**TOWN OF HERNDON, VIRGINIA
HERITAGE PRESERVATION REVIEW BOARD
WORK SESSION AGENDA
FEBRUARY 6, 2019
HERNDON COUNCIL CHAMBERS BUILDING
765 LYNN STREET
7:00 P.M.**

APPLICATION FOR A CERTIFICATE OF APPROPRIATENESS OF AN AMENDMENT TO AN APPROVED APPLICATION, HPRB #19-02.

An application to consider a Certificate of Appropriateness approving design revisions to the approved alterations, previously authorized through HPRB #17-15, to the commercial structure located at 765 / 767 Elden Street, Herndon (Attachment #1).

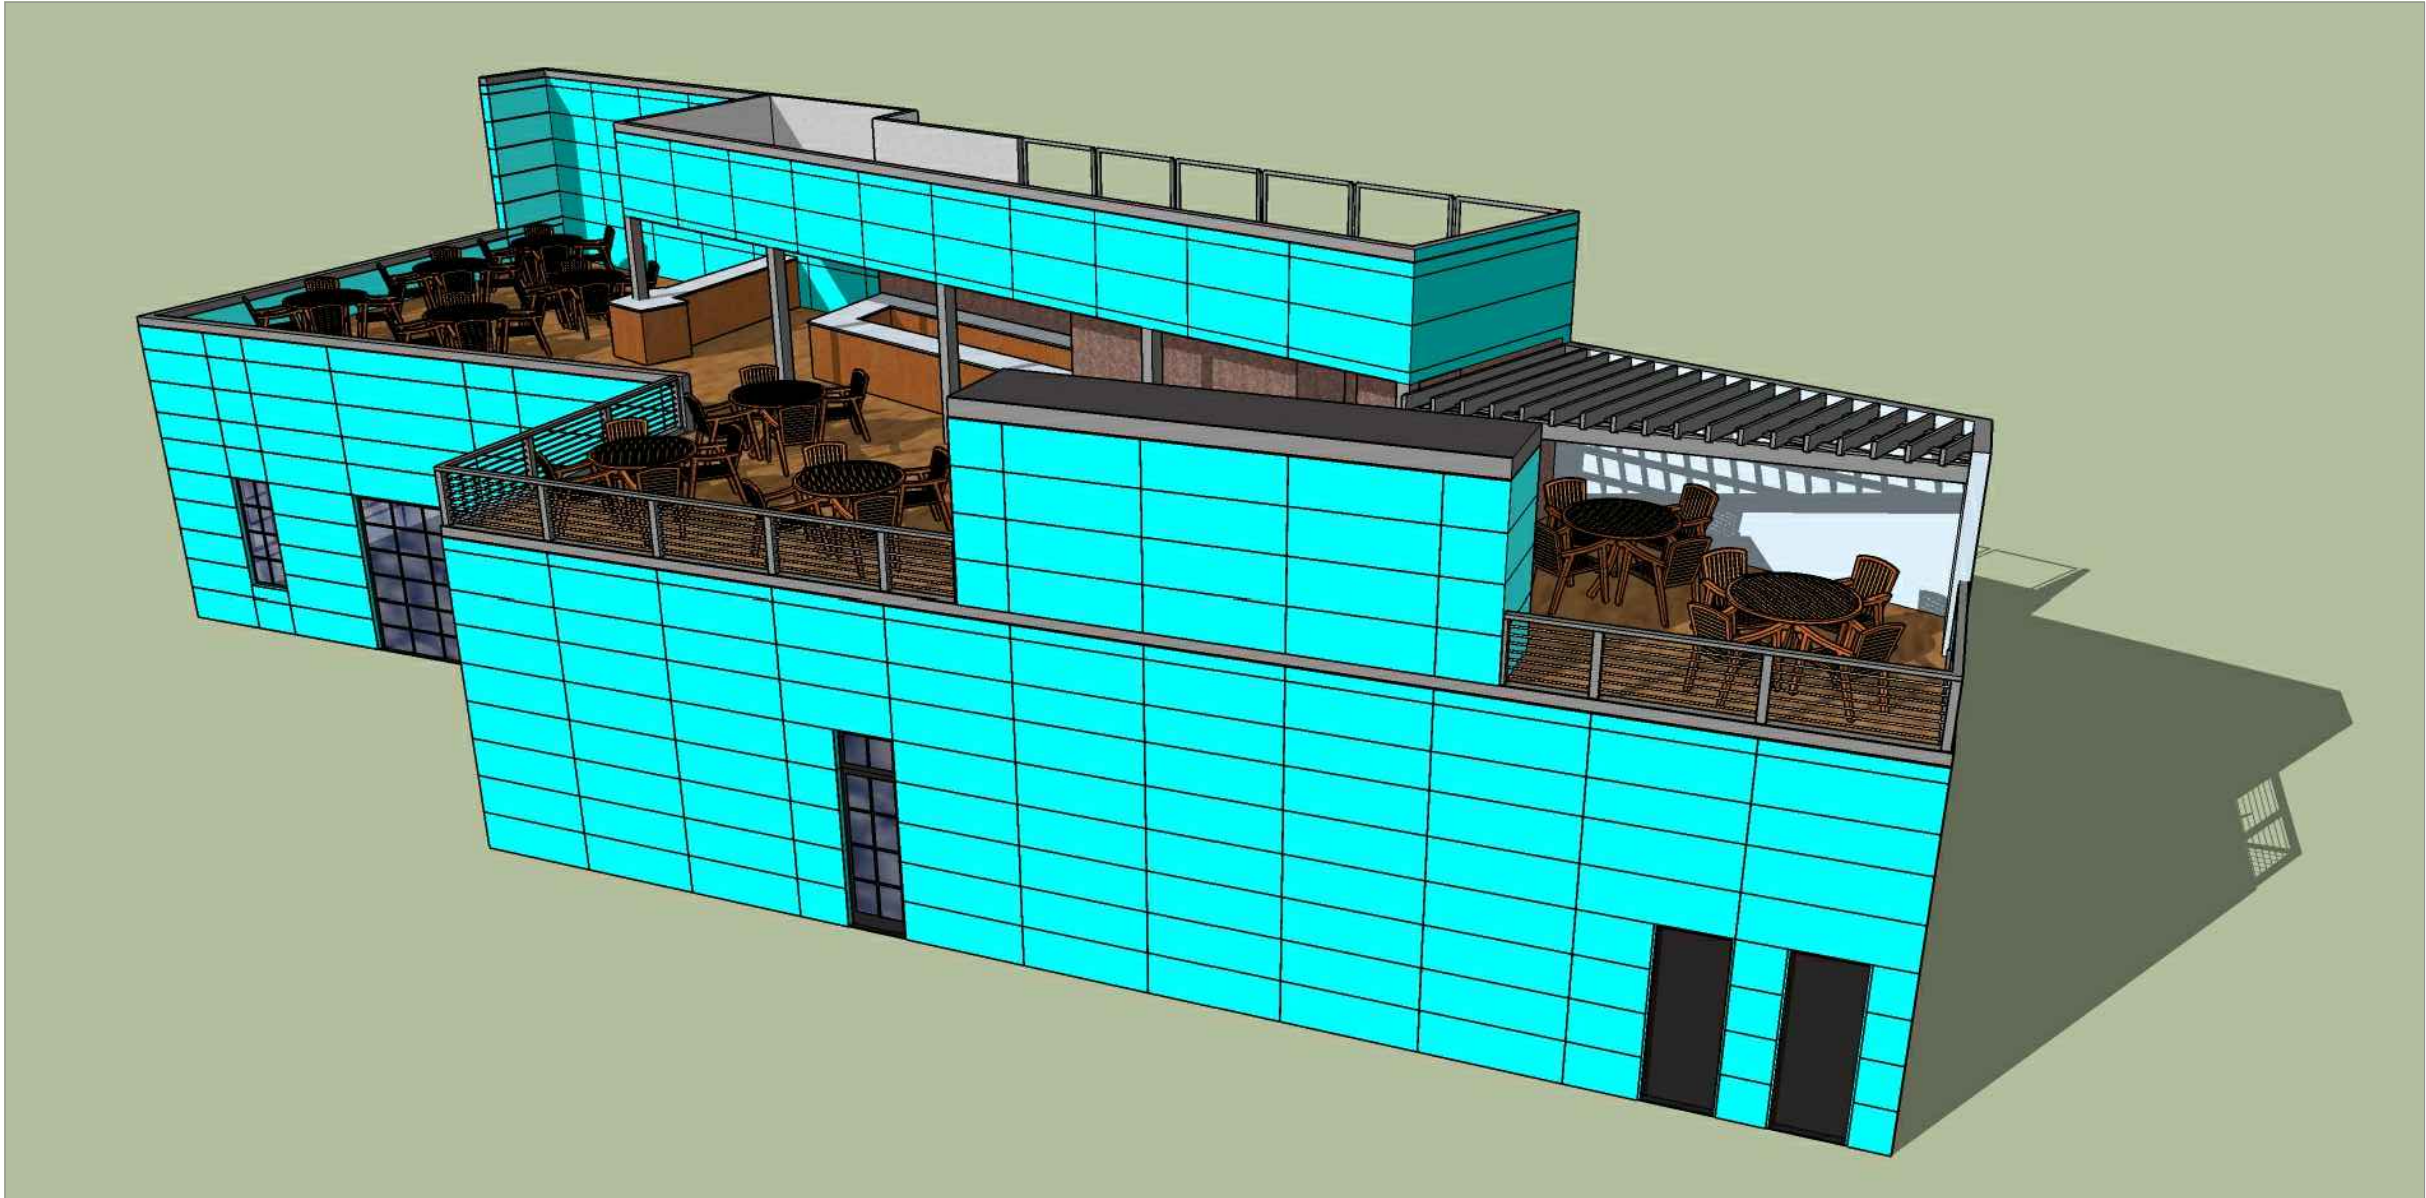
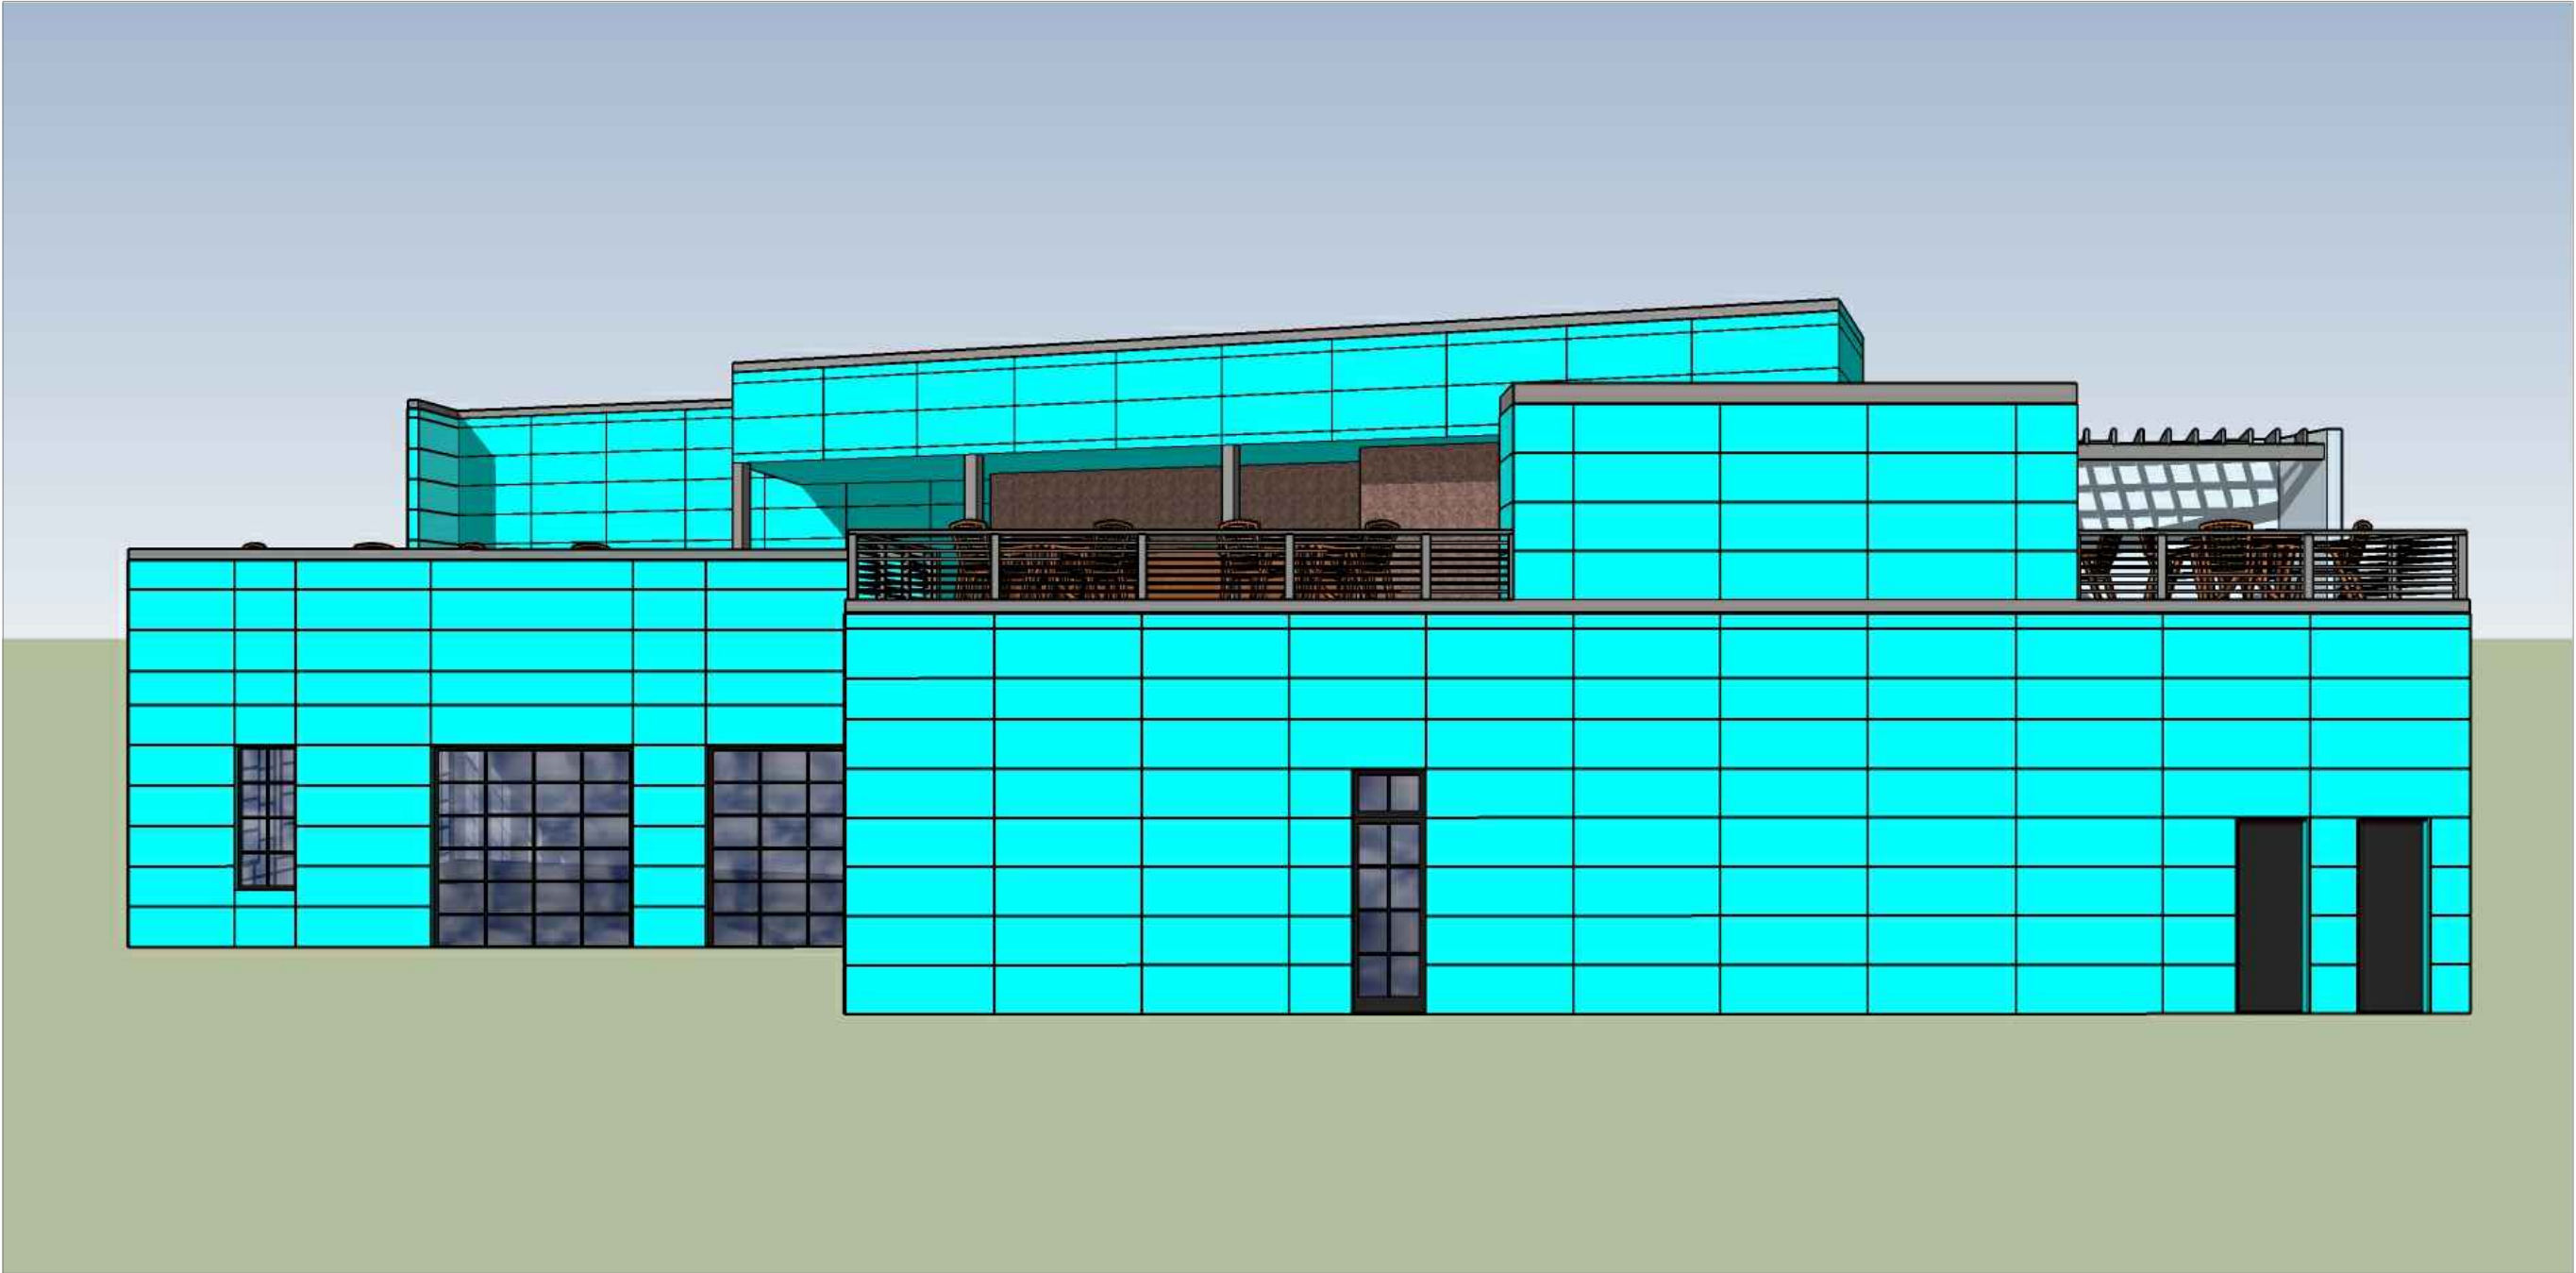
1. The applicant shall resolve the discrepancy of the Applicant Letter (Attachment #3) and the submitted building elevations with new drawings and/or formal description noting the following:
 - a. Identifying the second-floor walled enclosure with materials for the enclosure specified
 - b. Clarify the removal of the black wire mesh screen from the new elevation design(s)
 - c. Clarify the color variation of exterior building material between the original approval and the new design

- a. Identification and detailed information related to the new walled stairwell enclosure
 - b. Clarification and explanation of the removal of the black wire mesh from the second floor of the west and south elevations

- c. Clarification of the color variation between the original design and the revised design. The new design material color of the rain screens appears lighter in the revised elevations and perspective renditions.
